## TECHNICAL BULLETIN

[Issue No.] FA-A-0124-B

[Title] Change in the D-sub connector of MELSEC-Q/AnS/QnAS series modules

[Date of Issue] November 2011 (Ver. B: June 2012)

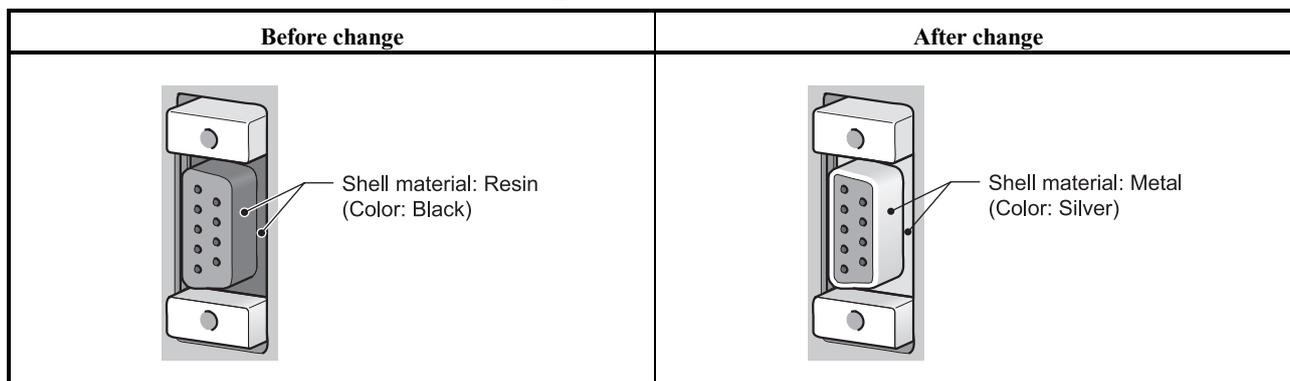
The shell material of the D-sub connector is changed from resin to metal.
